SUPPLEMENTAL RESTRAINT SYSTEM (SRS)

SERVICE BULLETIN		No.: MSB-97E52-004	
		Date: 1998-02-15	
Subject: CHANGE IN ATTACHMENT POSITION OF SRS AIR BAG CAUTION LABEL		<Model> (EC,EXP)L200 (K60,K70)	<M/Y> 97-10
Group: SUPPLEMENTAL RESTRAINT	Draftno: 97-SY-029		
INFORMATION	OVERSEAS SERVICE DEPT	 R. USAMI - MANAGER QUALITY INFORMATION ANALYSIS

This Service Bulletin informs you of change in attachment position of the SRS air bag caution label.

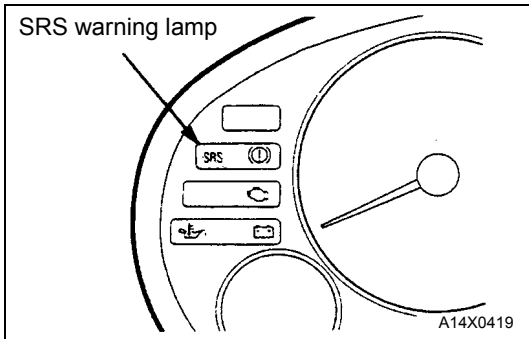
<Incorrect>

↑ **<Correct>**

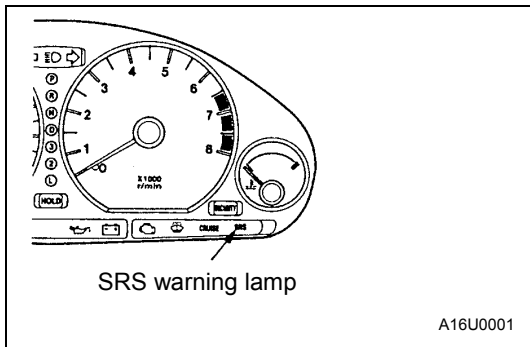
<Incorrect>

↑ <Correct>
